UNITED STATES PATENT AND TRADEMARK OFFICE

APPLICATION NO.	FILING DATE	FIRST NAMED INVENTOR	ATTORNEY DOCKET NO.	CONFIRMATION NO.
10/660,901	09/12/2003	Paul J. Wyser	KEL 006 P2	7410
34232 7590 02/12/2007 MATTHEW R. JENKINS, ESQ. 2310 FAR HILLS BUILDING DAYTON, OH 45419			EXAMINER ALEJANDRO, RAYMOND	
			ART UNIT 1745	PAPER NUMBER
SHORTENED STATUTORY PERIOD OF RESPONSE		MAIL DATE	DELIVERY MODE	
3 MONTHS		02/12/2007	PAPER

Office Action Summary	Application No.	Applicant(s)	
	10/660,901	WYSER, PAUL J.	
	Examiner	Art Unit	
	Raymond Alejandro	1745

DETAILED ACTION

FIG. 8

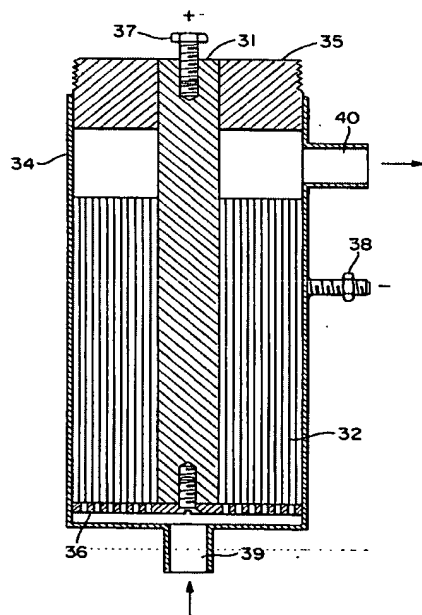
Robertson illustrates in **FIGURE 8** below an electrode arrangement for electrochemical cell (TITLE/ABSTRACT/COL 1, lines 5-7) comprising the electrode arrangement 32 comprising one anode and one cathode, each electrode is a nickel sheet and a separator therebetween (COL 5, lines 31-35). The core of the coiled electrode arrangement is a solid Ni-rod 31 (*the pin inside said housing*); the electrode sandwich 32: nickel foil, separator, nickel foil, separator is rolled up tightly around the Ni-rod 31; the electrode roll 31, 32 is lodged in a cell container (COL 5, lines 35-45). Further disclosed is an electrode roll with two electrodes and a point 12 representing the electrical connection of the electrode and the axle 30 (COL 4, lines 50-59); and the electrodes are wound tightly around a central core 30 (COL 3, lines 33-36).

The Ni-rod 31 makes electrical contact with the anode sheet of the roll and is provided with a connection bolt 37 (*the second connection between the first contact connection and the pin*) to serve as current feeder to the anode (COL 5, lines 45-50). The material for the construction of the electrodes includes metals; and the electrode may also have coatings made of

Robertson further discloses the incorporation of bus-bars 59, 60 to feed electricity from the power source to the electrical connections of the electrode rolls (COL 7, lines 45-55). The electrical connection to the electrode roll is made by mounting the bus-bars directly onto the ends of the electrode rolls; these provide connection to the complete edge of each electrode (COL 8, lines 37-43). *In this case, the bus-bars represent the first one contact connection which is fitted to an outer face of the housing.*

As per Robertson's disclosure, electricity is applied to the cell and the current density is adjusted at 2.33 mA/cm^2 (COL 5, lines 65-68). *Robertson discloses an electrochemical cell (a battery) regardless of whether it is used for electrochemical production of current or current is being fed into the cell.*

The Ni-rod 31 makes electrical contact with the anode sheet of the roll and is provided with a connection bolt 37 (*the second connection between the first contact connection and the pin*) to serve as current feeder to the anode (COL 5, lines 45-50). *In this context, the head of the bolt 37 forms the first contact.*

Fig.7

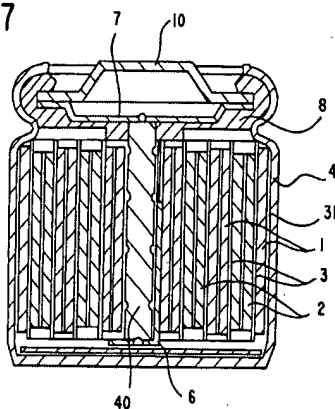
Nagaura illustrates in **Figures 7, 10b and 12b** the features of the claimed invention. Nagaura teaches a non-aqueous battery comprising a battery element consisting of a strip-shaped positive electrode 2 and negative electrode 1 which have metallic foils as current collectors being separated by a separator 3 and wound into a jelly roll (**CLAIM 3/ EXAMPLE 4/ Figure 7**). The battery element is housed in a battery casing and an opening of the casing has a lid 7 (*the second connection between the first contact and the pin*) affixed to it and in which cylindrical battery a metallic rod 40 (*the pin inside the housing*) is inserted into a hole in the center of the battery element, to one end of which said rod is welded to a positive electrode lead or a negative electrode lead and to the other end of which is welded said lid 7 (**CLAIM 3/ EXAMPLE 4/ Figure 7/COL 15, lines 30-35**). Positive external terminal 10 (*the first contact fitted to an outer face of the casing*) is then laid on top of and in contact with sealing lid 7 (COL 12, lines 3-5). Electrode lead 6 is welded to the one end of the Al-rod is in close proximity to the hole in the center of the coiled battery element (COL 12, lines 10-14). *Any one of the positive electrode lead, negative electrode lead or even the strip shaped current collectors may serve as the*

metallic supporting strip. Particularly, either the positive electrode lead or the negative electrode are directly welded to the rod 40. Nagaura describes a charging current of 500 mA (COL 14, lines 1-10).

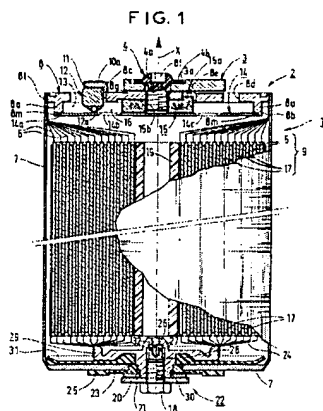
Figure 1 of Souliac et al illustrate battery cell 1 comprising a container in the form of a cylindrical can 7; and at least one alternation of positive electrode, negative electrode and separator wound in a spiral form (COL 3, lines 53-63). Souliac et al disclose that the end of the cell incorporate the negative terminal 22; wherein blades 24 are connected to the negative electrode and welded to a connecting part 29 which is in contact with a screw 18 which immobilizes a nut 20, and two washers (COL 4, lines 1-16). Included is also a screwthreaded housing 30 at the center of the connecting part 29 providing access thereto. All that is then required to make the electrical connection to the outside of the cell 1 is to accommodate the screw 18 in the external part of the housing 30 and to collect the current from the screw 18 by any appropriate means (COL 4, lines 1-16). Disclosed is a cell which is compact (COL 1, lines 25-27). Reference numeral 19 is a support (COL 3, lines 60-63) wherein the cell is assembled by winding the alternating electrodes 5, 17 and separator around the support 19 (COL 6, lines 16-23). Blades 24 are welded to the connection part 29 (COL 6, lines 18-21). Connection part 29 is welded to the blades 24 which (COL 6, lines 16-22) and blades 24 are connected to the negative electrode (COL 4, lines 5-10). *Thus, connection part 29, serving as applicant's pin as interpreted by the examiner, indirectly provides mechanical support to the wound electrode assembly.*

Additionally, it is disclosed that an electrical connection member 3 external to the cell 1 is fixed to the cover 8 at the end 2, the two parts 8 and 3 being fastened together by clamping means using a nut and a screw 4 external to the cell (COL 4, lines 40-52). The screw has a head 4a and ring inserted into the housing. The cover also includes a screwthreaded opening 8f accommodating part of the screw (COL 4, lines 40-52).

Note: In this instance, it is noted that the two screws (first and second pins) are electrically connected as instantly claimed and they are tightened mechanically.

Souliac et al use screws themselves or screw-based connections to connect the battery (COL 4, lines 1-16/COL 4, lines 40-52/ See FIGURE 1).

Furthermore, the cell of Souliac et al also comprises a nut 15 which also provides electrical connection and mechanical stability to the screw on the positive electrode side (See FIGURE 1). Souliac et al disclose that such a nut is a nickel-plated steel element (COL 4, lines 40-45). *If feature 15 represents the contact board, thus, as seen above in the enlarged portion of Figure 1, feature 15 is arranged in a depression in the housing.*

As illustrated in **Figure 1** above, the cell of Souliac et al at least comprises two screw (pins) in electrical connection with the electrodes thereof (See FIGURE 1).

Enlarged portion of Figure 1 below depicts the screw 18 being in the form of a small tube (See Figure 1). *Additionally, it is apparent that the tube form of the screw per se provides the claimed broadened area in the screw to allow it to support therefrom. Absent further description of the structure of the broadened area, it is contended that the screw does have broader sections along its length that allow it to support in the battery case.*

As illustrated above in **Figure 1**, only one screw is held at only one end (See FIGURE 1).

Either nut 20 or electrical connection member 3 serves as the contact board (See FIGURE 1). Moreover, as seen below feature 3 is divided into two sections, one section on the right and another section on the left (See Enlarged Portion of Figure 1 below). *Also, since at least electrical connection member 3 provides electrical connection therebetween, it can be reasonably argued that it is an electronic component. Unless the present claims provide further*

Fig.7

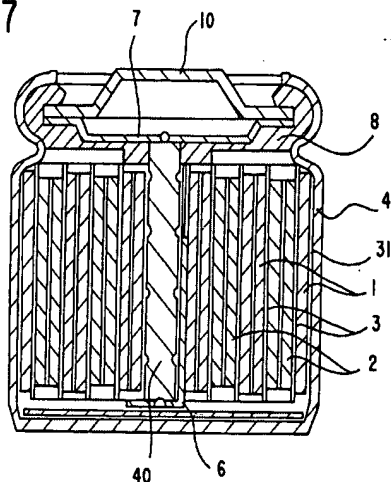
Nagaura teaches a non-aqueous battery comprising a battery element consisting of a strip-shaped positive electrode 2 and negative electrode 1 which have metallic foils as current collectors being separated by a separator 3 and wound into a jelly roll (**CLAIM 3/ EXAMPLE 4/ Figure 7**). The battery element is housed in a battery casing and an opening of the casing has a lid 7 (*the second connection between the first contact and the pin*) affixed to it and in which cylindrical battery a metallic rod 40 (*the pin inside the housing*) is inserted into a hole in the center of the battery element, to one end of which said rod is welded to a positive electrode lead or a negative electrode lead and to the other end of which is welded said lid 7 (**CLAIM 3/ EXAMPLE 4/ Figure 7/COL 15, lines 30-35**). Positive external terminal 10 (*the first contact fitted to an outer face of the casing*) is then laid on top of and in contact with sealing lid 7 (COL 12, lines 3-5). Electrode lead 6 is welded to the one end of the Al-rod is in close proximity to the hole in the center of the coiled battery element (COL 12, lines 10-14). *Any one of the positive electrode lead, negative electrode lead or even the strip shaped current collectors may serve as the metallic supporting strip. Particularly, either the positive electrode lead or the negative*

electrode are directly welded to the rod 40. Nagaura describes a charging current of 500 mA (COL 14, lines 1-10).

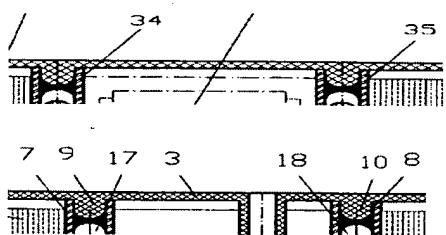
In view of the above, it would have been obvious to a person of ordinary skill in the art at the time the invention was made to weld the specific metallic supporting strip to one pin of Souliac et al as taught by Nagaura because Nagaura teaches that by having the specific metallic supporting strip welded to the pin (rod) there is no need to fold the electrode lead to enable the installation of the lid as in conventional methods, meaning that only a very short electrode lead is required (Nagaura at COL 15, lines 30-52). Accordingly, under Nagaura's invention, there will be no batteries which do not function fully due to poor electric conduction between the metallic casing and the electrode, thereby, boosting battery reliability. As this invention requires only a very small cross-sectional area, there is also no concern about temperature increases in the electrode lead due to the passage of large currents (Nagaura at COL 15, lines 30-52). This removes the danger of batteries catching fire when the electrode lead becomes the source of ignition, particularly in non-aqueous cylindrical batteries which use combustible organic electrolytes. Eliminating the need to spot weld the electrode lead to the casing bottom also allows

the housing of the battery element after electrolyte has been impregnated into the battery element, enabling the removal of the process of injecting electrolyte into the metallic casing, which has seriously hampered productivity (Naguara at COL 15, lines 30-52).
